RESPONSIVENESS SUMMARY

**NEW BEDFORD HARBOR SUPERFUND SITE
HOT SPOT OPERABLE UNIT**

NEW BEDFORD, MASSACHUSETTS

APRIL 1990

FIGURE 1.1

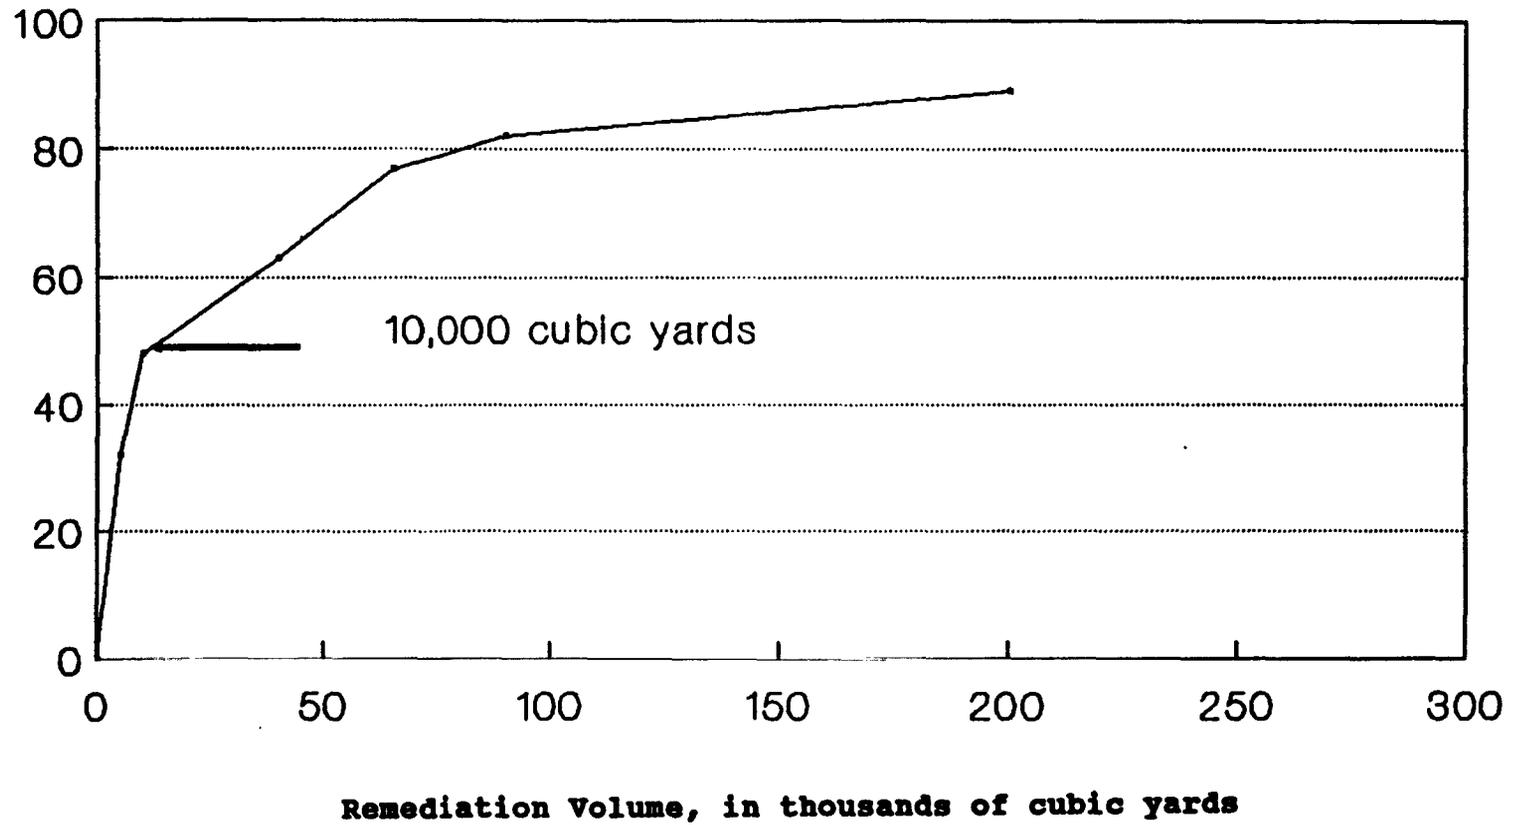
Figure 1.1 at the end of this Section depicts the relationship between the percentage of PCB mass and sediment volume in cubic yards for the Upper Estuary. As the number of cubic yards increases, the percentage of PCB mass per cubic yard decreases. The rate of change in the percentage of PCB mass as it relates to volume in cubic yards varies. At 4,000 ppm, or 48% PCB mass, the slope of the curve changes dramatically. Above this point, the rate of increase in percentage of PCB mass, as it relates to sediment volume, markedly diminishes. By using a target level of 4,000 ppm, EPA will remove the greatest percentage of PCB mass for the least volume of sediment. In EPA's judgment, removing sediment at 4,000 ppm and greater takes advantage of the steepest parts of the curve.

FIGURE 2.1

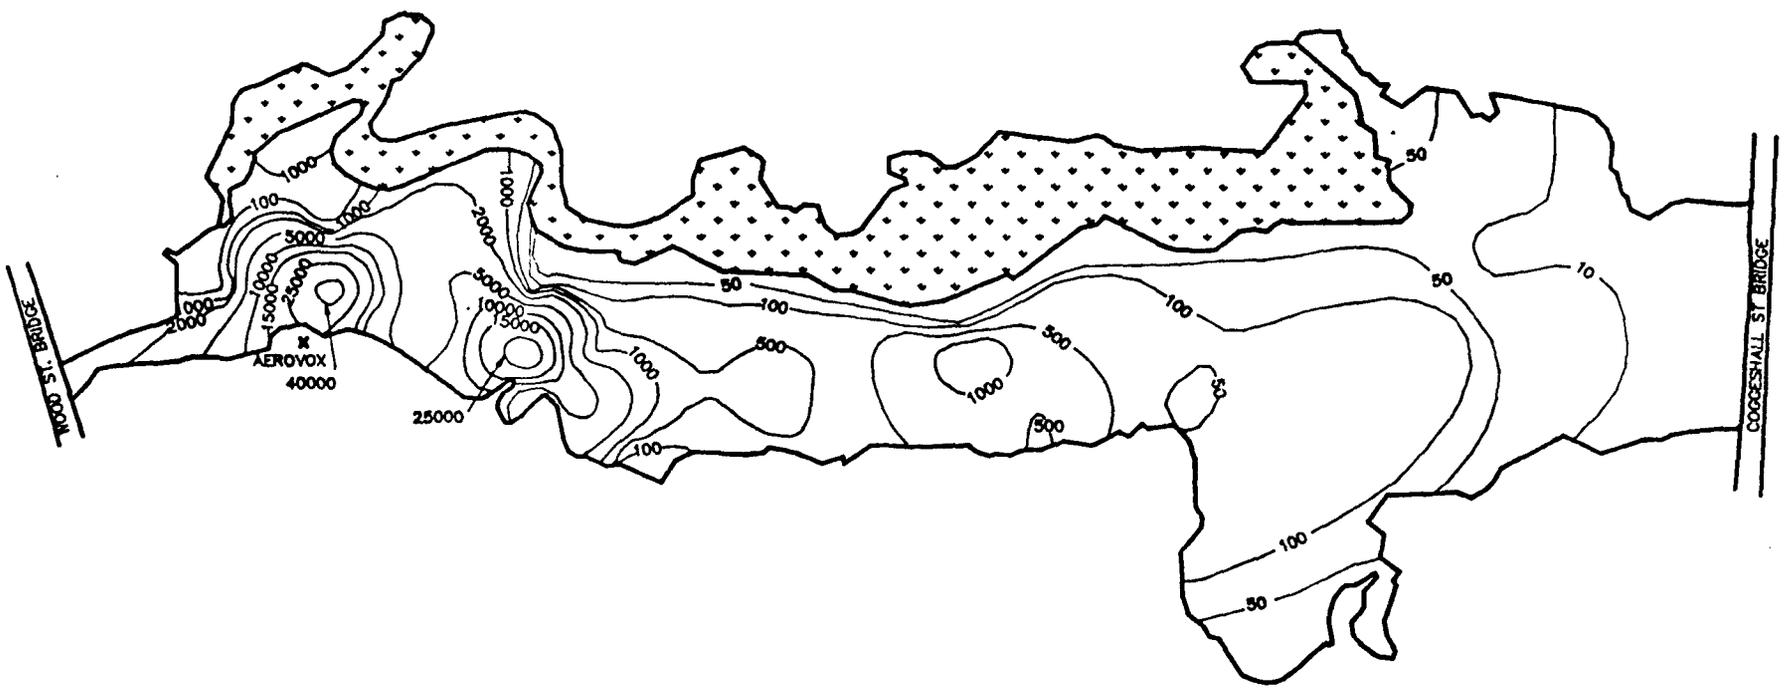
The PRPs' generated a contour map using EPA's data and it is presented in Figure 2.1 at the end of the Section. According to the PRPs, the kriging method produced results that, "represent reliable estimates of constituent masses and deposition in New Bedford Harbor upper Estuary sediment" (Balsam, 1989a). The PRP map (Figure 2.1) shows a similar extent of PCB contamination when compared to EPA's contour map (Figure 2.2). Both of these maps are validated by the PCB sediment sampling and analytical results from the thin layer sampling program conducted by the PRPs (Balsam, 1989b).

FIGURE 3.1

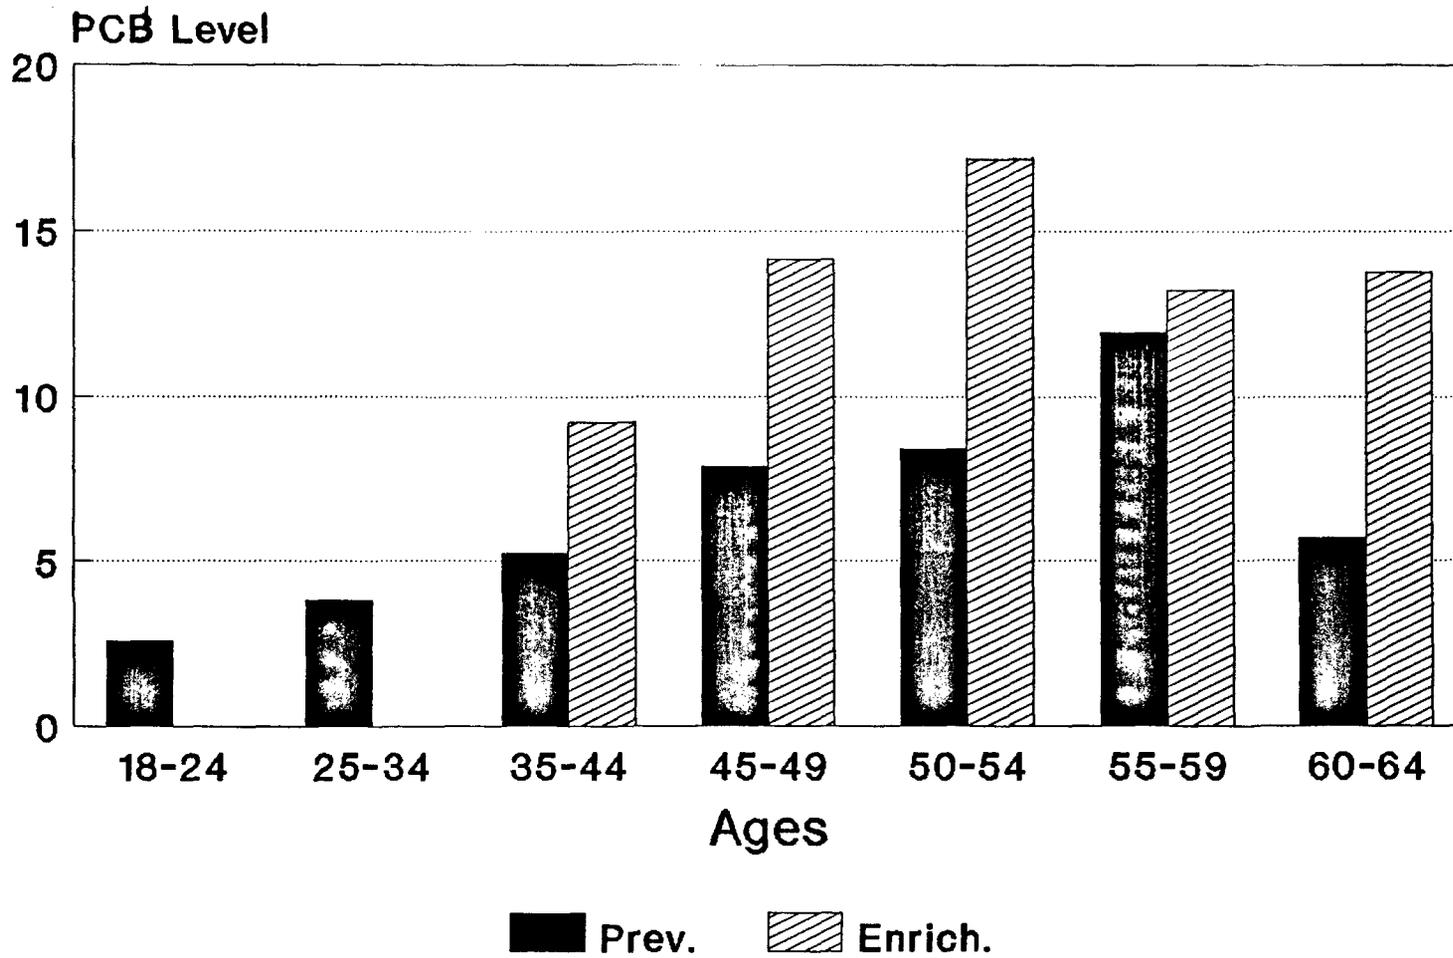
1. Those individuals who more likely ate contaminated seafood (enrichment sample) presented higher serum PCB levels than individuals who were less likely to eat contaminated seafood (prevalence sample). These results are shown in Table 3.4.
2. The relationship described above in #1 was consistently observed for each age group represented. These results are shown in Figure 3.1.

FIGURE 3.2

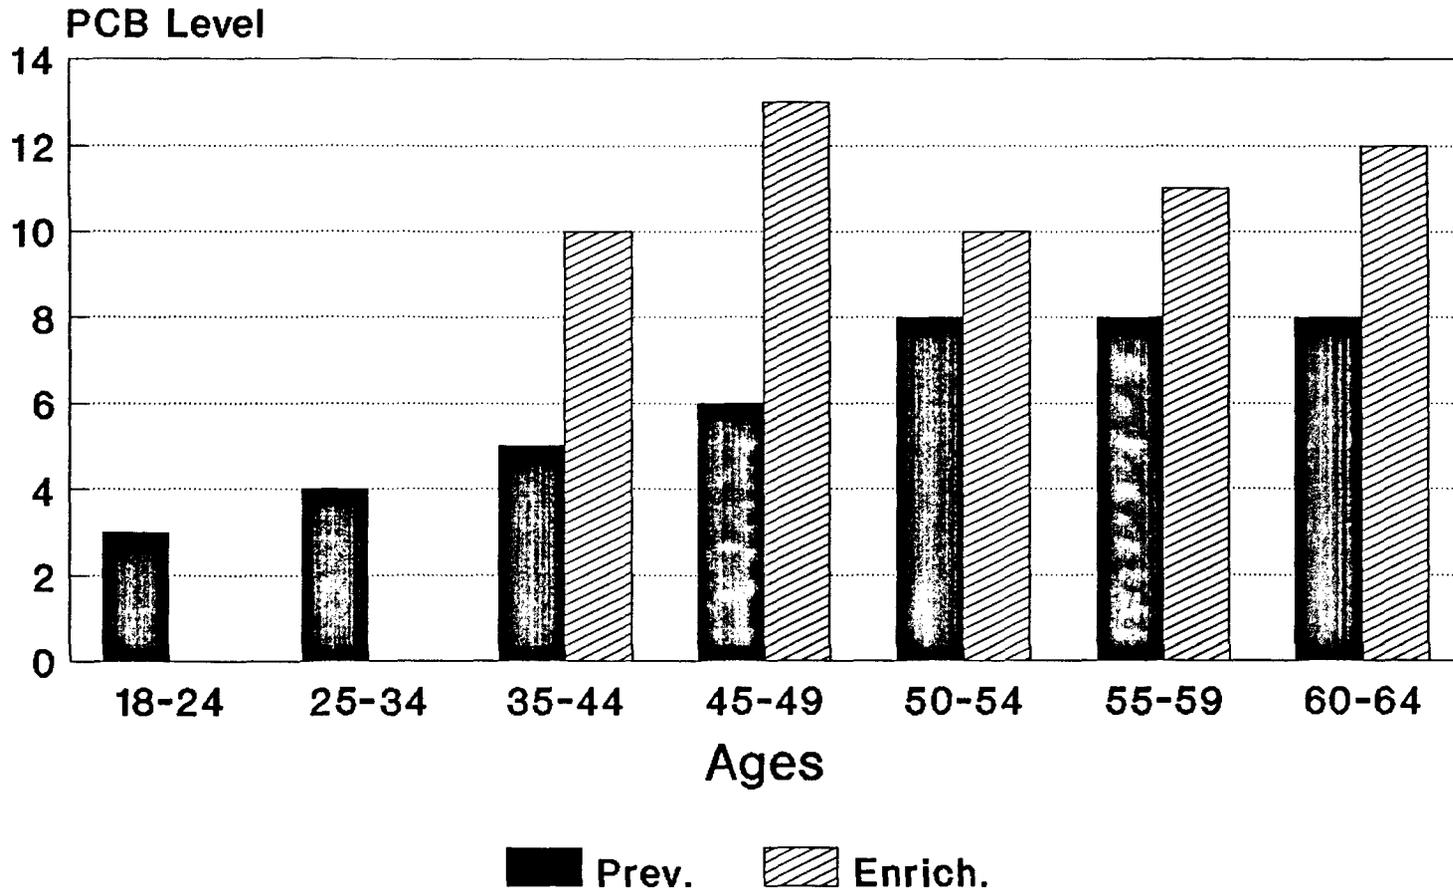
3. Additionally, this pattern remained when the individuals with possible occupational exposure to PCBs were removed from the analysis. These results are shown in Figure 3.2.

FIGURE 3.5

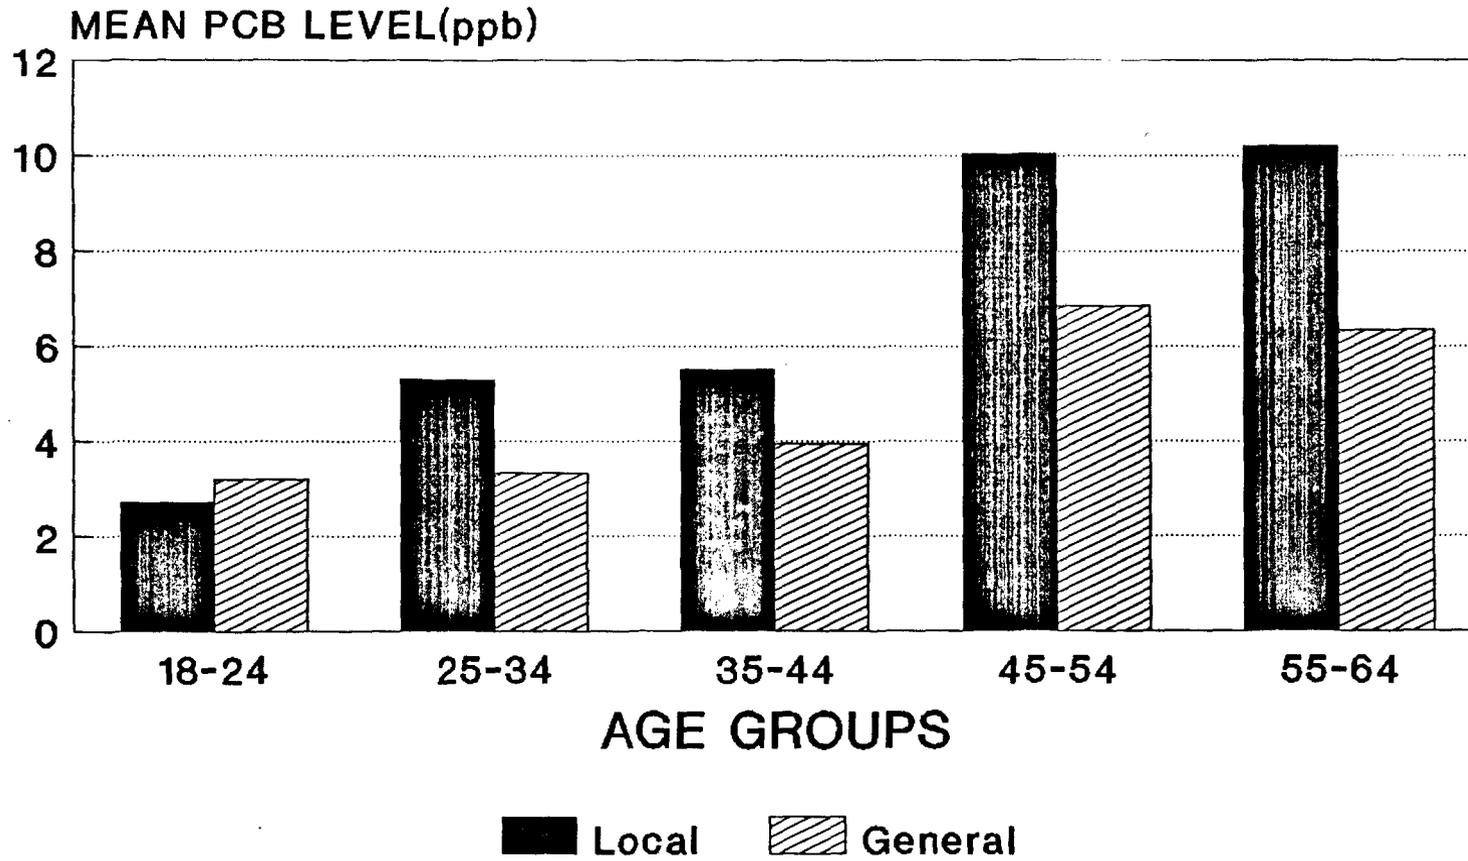
8. Figure 3.5 presents the prevalence sample serum PCB levels for those who consumed locally caught contaminated seafood versus general seafood type according to age. While the numbers are small for each age group, the same trend observed in the enrichment sample can be seen among those who ate locally caught contaminated seafood among the prevalence sample. Serum PCB levels are higher in every age group except the 18-24 group for the local seafood consumers compared to the general seafood consumers. The observations that:

FIGURE 4-1

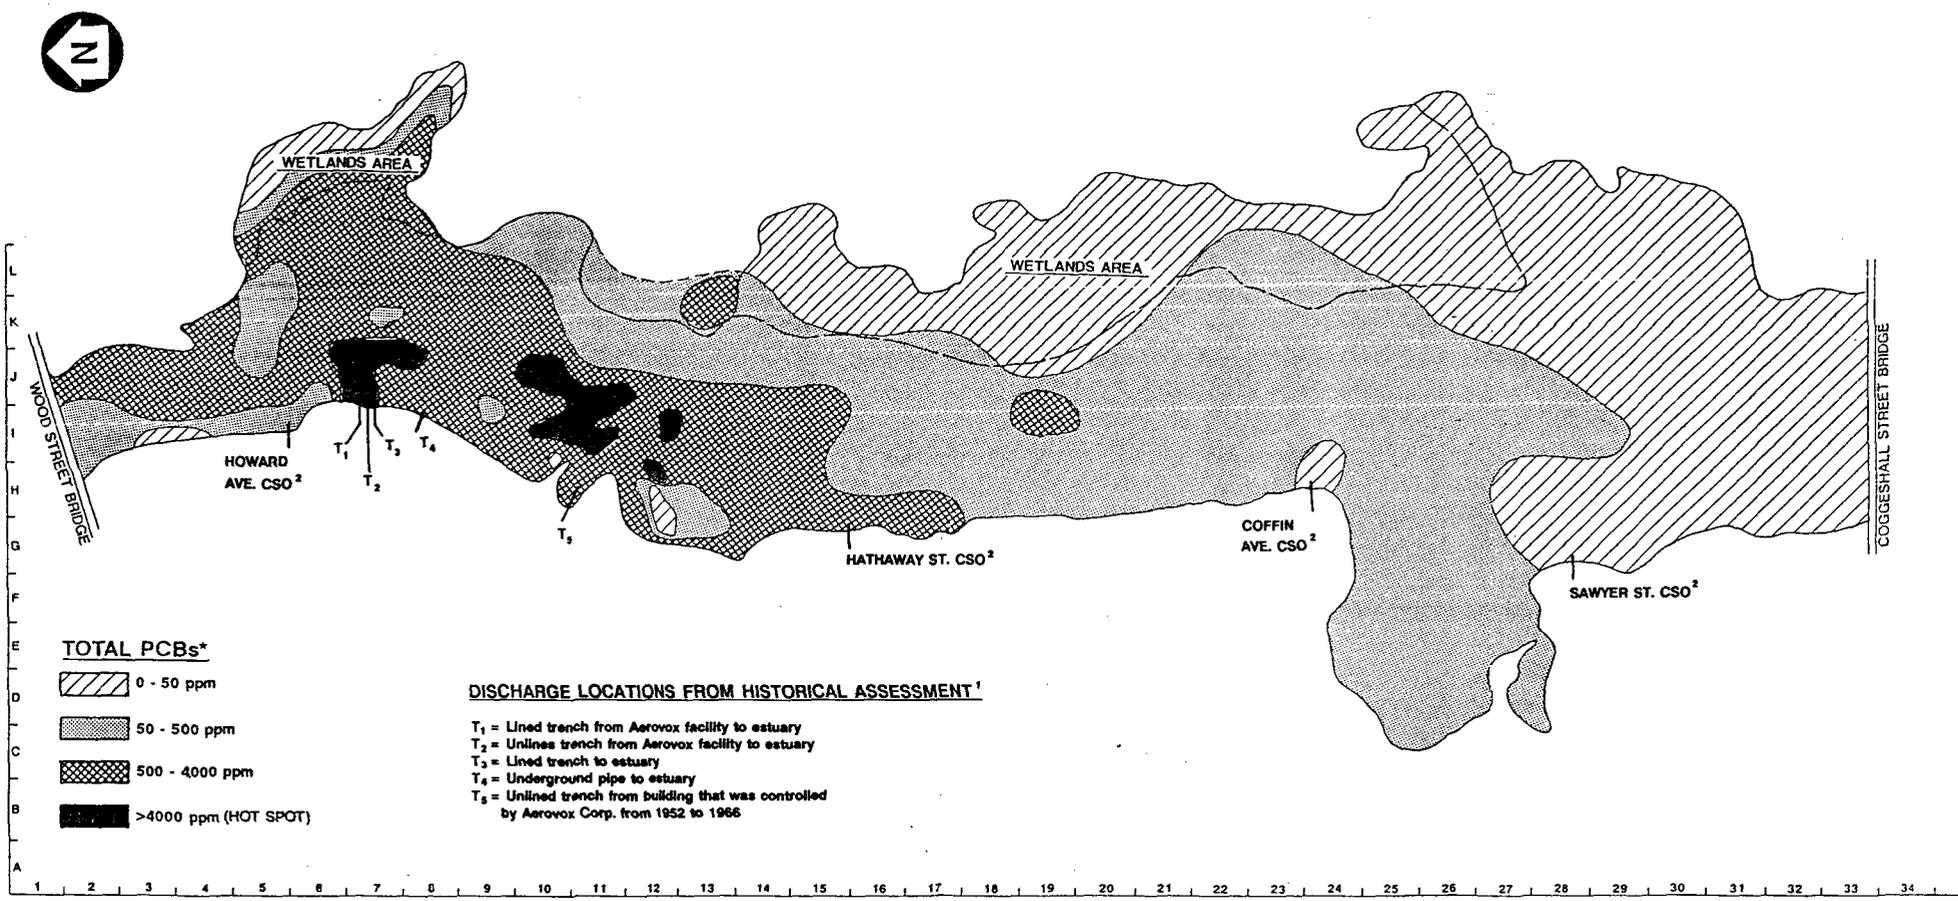
Further evidence of the important role of the Hot Spot is apparent in the flux modeling conducted by PRPs. This modeling estimates at least 30% of the total PCB flux is derived from the areas of contamination in excess of 4,000 ppm PCBs (i.e., the Hot Spot). Figure 4-1 at the end of this section illustrates this information.
